## Federal Recall Information

11KWC

Kenworth Truck Company

T440 Quick Release Valve Missing

Fig. 1

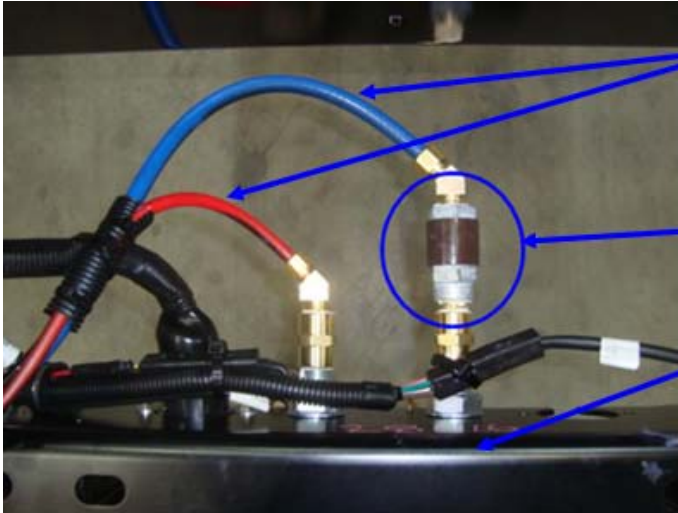
The quick release air valve required in the full truck service brake air line gladhand connection may have not been installed in certain vehicles (Ref. Figure 1). The absence of the quick release air valve may allow the full truck service brake air line gladhand release timing to exceed the threshold of 0.75 seconds failing to comply with the requirements of FMVSS 121.

Brown Valve Shown May  
Have Not Been Installed

The remedy of the recall will involve installation of the quick release air valve in the full truck service brake air line with gladhand connection as shown above in Fig. 1.

Install the quick release valve per Fig. 1 above.
